DATE: June 17, 2026

TO: CHAIR AND MEMBERS OF THE
BOARD OF ARCHITECTURAL REVIEW

FROM: HISTORIC PRESERVATION STAFF

SUBJECT: CONCEPT REVIEW #2 OF 415 North Alfred Street
BAR 2025-00552

1 PROPOSED REAR ELEVATION
1/4" = 1'-0"

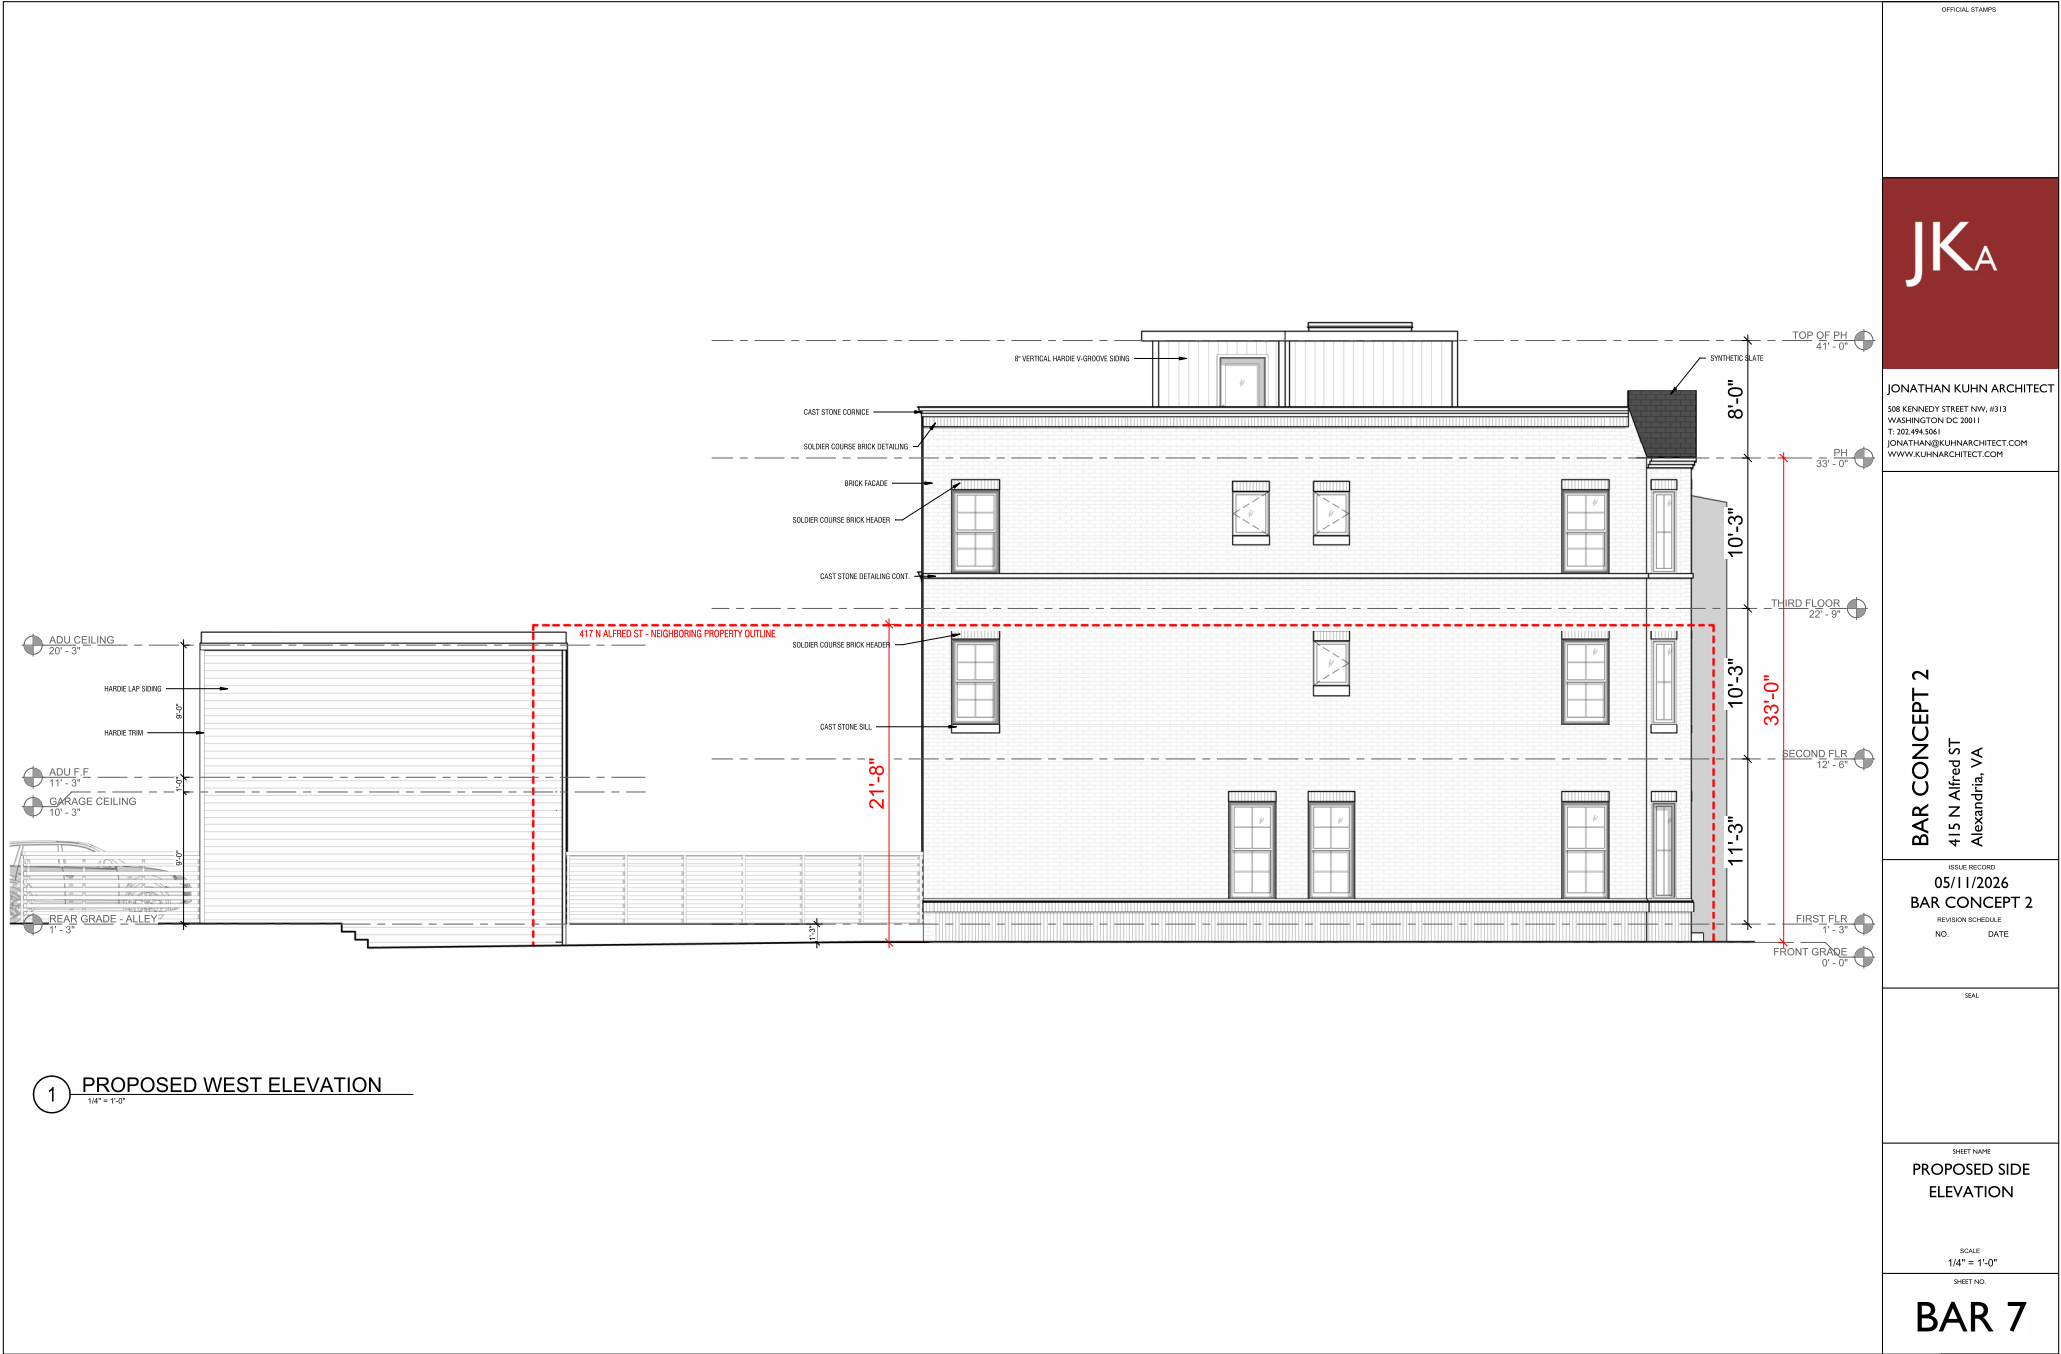
In the previous submission, there was little information on the design for the ADU units at the rear of the site. Based on feedback from staff and the Board, the applicant has revised the design to include three windows per unit facing the alley and a recessed portion with vertical wood siding and a sliding door (Figure 6). Staff finds that the revised design is an improvement over the original and is reminiscent of alley houses that are found throughout the district. Staff supports the proposed height, mass, scale, and architectural character of the ADU structures and recommends endorsement of this portion of the project as well.

- The applicant should study the pattern of the ADU units to create a successful overall composition.
- The garage doors at the ADUs extend nearly the full width of the rear elevation, leaving the space between the doors very narrow. The applicant should look at the size of the doors relative to the wall space and the detailing of the piers to achieve a balance between solid and void.

- 1. IMPROVED OVERALL ADU DESIGN, ADDED MORE WINDOWS, INCREASED HEIGHT AND MATERIALITY CHANGE.

2 MASSING STUDY - STREET ELEVATION
1/8" = 1'-0"

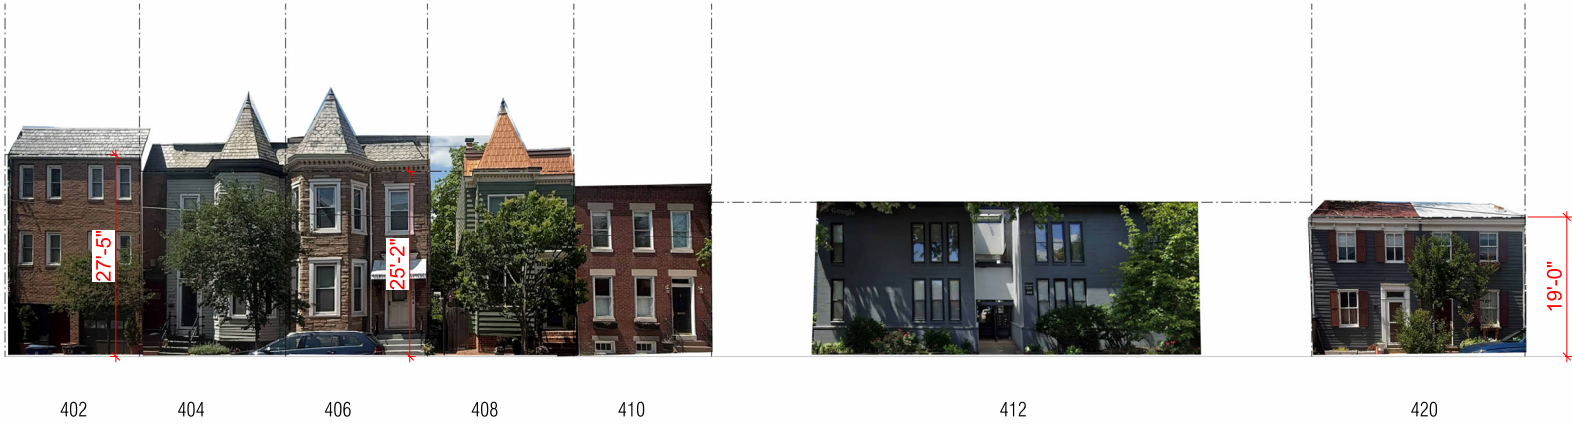
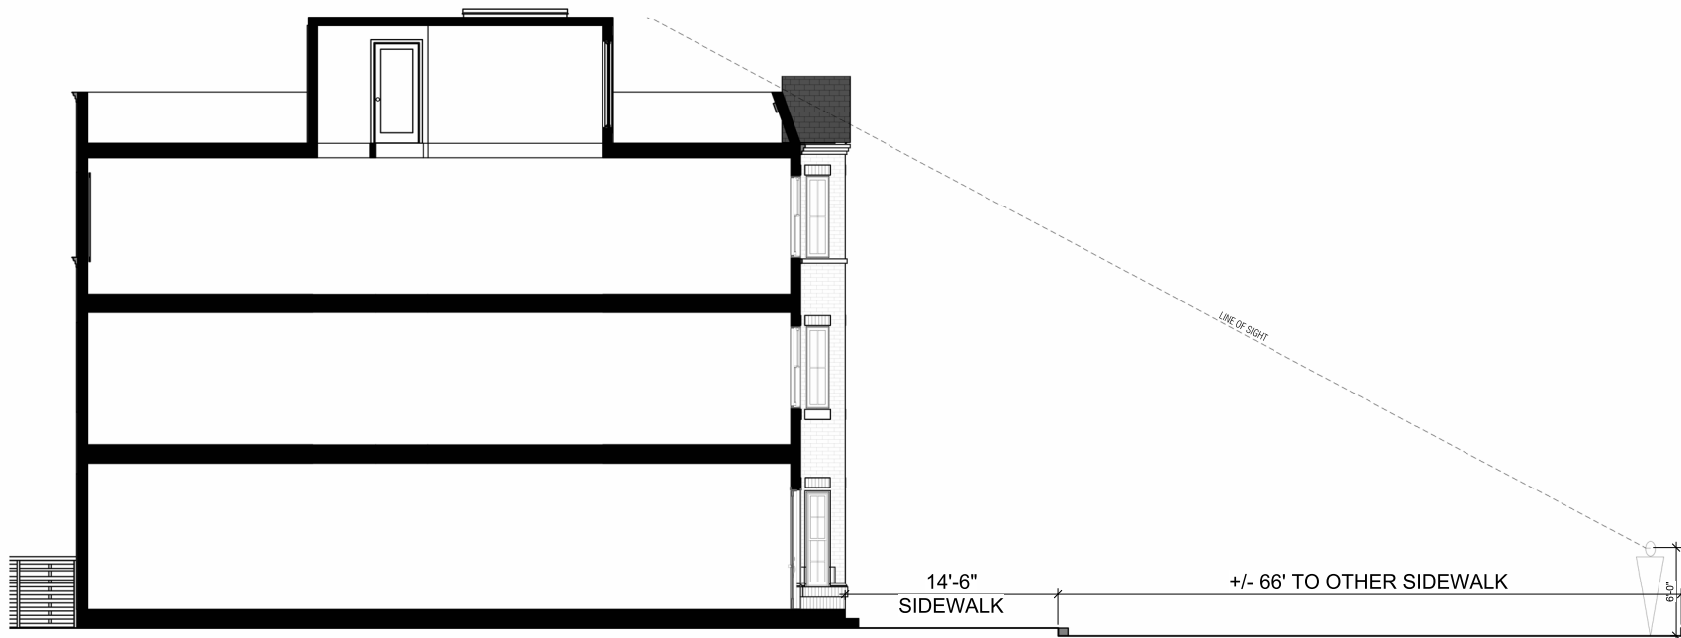
Within the historic districts, the Board utilizes the *Design Guidelines* to determine if a potential new building or additions would be compatible with nearby buildings. The townhomes are 22'-9" in height to the third floor, 33'-0" to the roof deck, and 41'-0" to the rooftop penthouse. The majority of structures on this block are two or three stories with entries located above the level of the sidewalk. The modern townhouses to the south of the subject property are generally larger than the historic buildings on the block (Figure 4) and are similar in height to the proposed townhouses. Staff finds that the proposed building massing is consistent with the Design Guidelines direction regarding compatibility with nearby structures.

The *Design Guidelines* state that “Building height should generally reflect the existing heights of buildings in the immediate vicinity of the proposed new construction.” The 400 block of North Alfred Street is a collection of different types of structures including two and three story townhomes and a two story multi-unit building across the street from the project site. The buildings to the south of the project site are currently some of the tallest on the block so the location of the proposed townhouses in their vicinity make sense. Staff supports the proposed height, mass, and scale of the project and recommends endorsement from the BAR.
